Determination 2008/13

Refusal of a consent for a farm implement storage shelter at 379 Heywards Road, Clarkville, Kaiapoi

Figure 1: Section through the shed

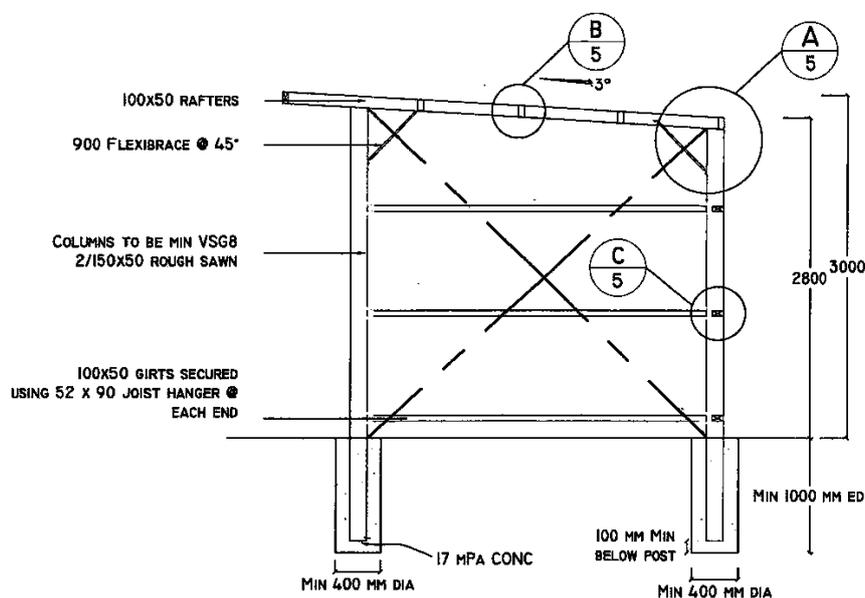
- 5.7 In the case of this farm shed the lower girts (to be made of Douglas fir treated to H1.2) will be vulnerable to exposure to moisture. Being immediately adjacent to the open side, they will inevitably be exposed to some wind-driven rain, possibly surface water coming under the cladding and possibly moisture from the ground or any vegetation or other debris, and consequently at risk of moisture penetration. The girts affected will receive some protection from the timber columns, walls and the roof extension over the open side, for example the exposed end grain will be protected, and provided the lower girts are sufficiently clear of the ground to allow adequate drying they should not be exposed to moisture for long periods. Nonetheless they cannot as currently designed be accurately described as “Members not exposed to weather or ground atmosphere and in dry conditions”. The reference by the applicants to Clause 110.2(f) is therefore not valid.

- 5.11 As referenced in paragraph 5.7, there is some exposure to exterior weather conditions, and, if the girts were too near the ground, there could also be exposure to ground moisture or surface water. Reducing the more chronic exposure to ground moisture, relocating the girts away from surface water and providing for more effective drying will achieve an environment more nearly akin to that described in Clause 110.2(f). Consideration can also be given to the treatment level of the Douglas fir which is a compensating factor for non compliance with the acceptable solution.

- 5.12 I therefore consider the code compliance will be achieved by modifying the design of the shed and raising the bottom girt to a suitable height above the ground. This may depend on the nature of the ground and location but I note that figure 65 of E2/AS1 indicates framing within a wall with a clearance above unpaved ground of a minimum of 225mm which may provide a guide to the territorial authority. This may result in the lower edge of the cladding being more susceptible to damage but I consider that in these applications the life of the cladding should not be significantly reduced.

- 6.1 In accordance with section 188 of the Building Act 2004, I determine that, subject to receiving all the necessary documentation to support the consent application (see reference to the amended girt height in paragraph 5.12), the territorial authority shall issue a building consent for the proposed farm shed.
